**November 26, 2013**

**USDA Forest Service  
Objection Reviewing Officer  
EMC, RPC-6th Floor  
Attn: Judicial and Administrative Reviews  
1601 N. Kent St  
Arlington, VA 22209**

Pursuant to 36 CFR 219 regulations, this is an objection to the Land Management Plan – 2013 Revision (LMP) and draft Record of Decision for the Kootenai National Forest (KNF) on behalf of the Alliance for the Wild Rockies. The Responsible Official is Faye Krueger, Regional Forester of Northern Region, USDA Forest Service.

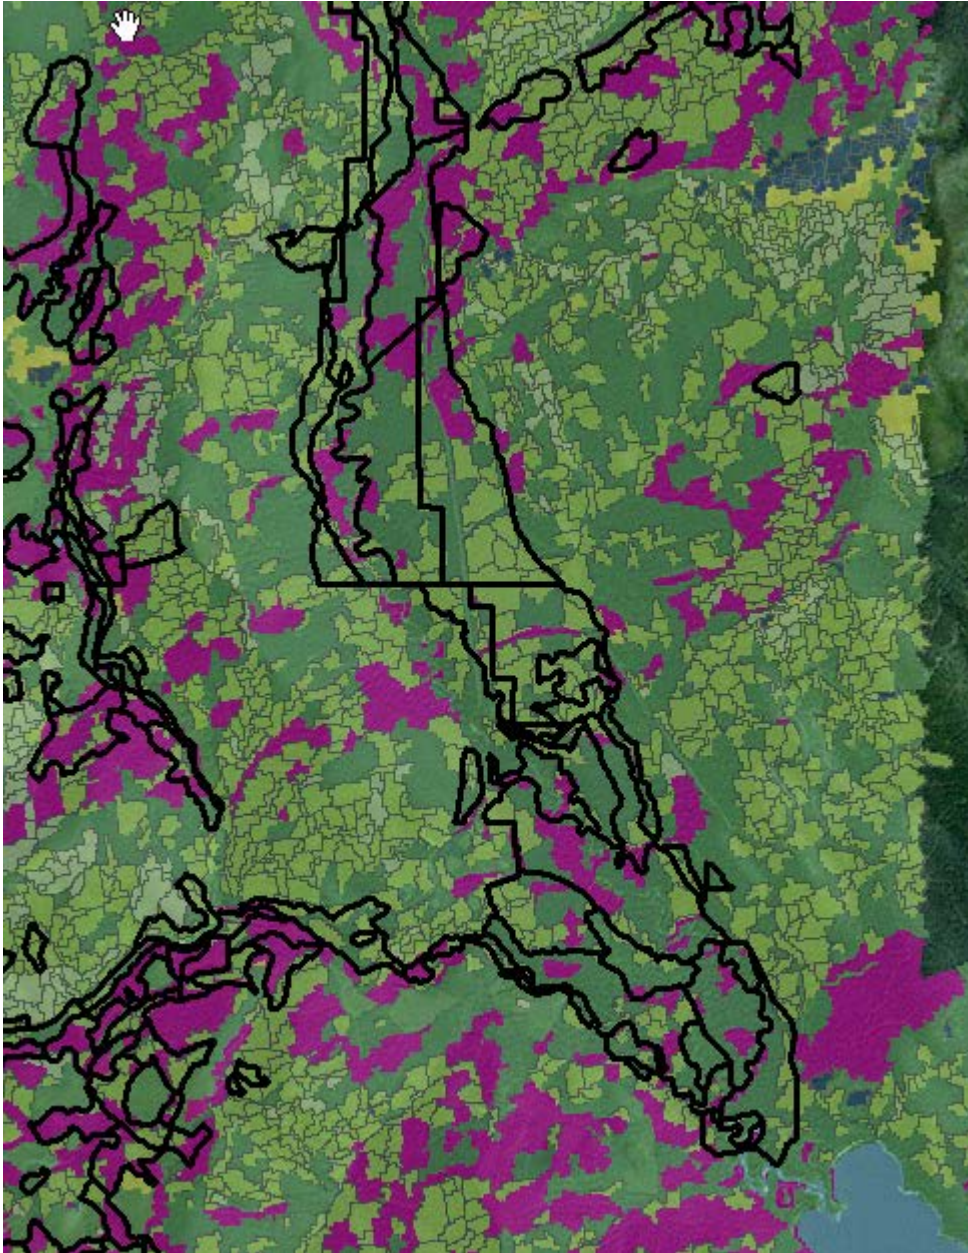
There are not only producer errors but locational errors are extreme. [Note: We use examples from the Idaho Panhandle National Forests (IPNF), because the Wildlife Habitat Assessment for the Kootenai and Idaho Panhandle Plan Revision Zone combined both the IPNF and the KNF.]

The image below shows the Green Monarch area along Pend Oreille Lake. The image is approximately 3.9 miles across, the area consists of open steep slopes and cliffs with small patches of trees. The area has a map classification of large diameter trees (15"+) without accounting for canopy cover. When canopy cover is added it is only slightly more accurate. In addition a substantial portion is classified as water as seen in the center left of the image.
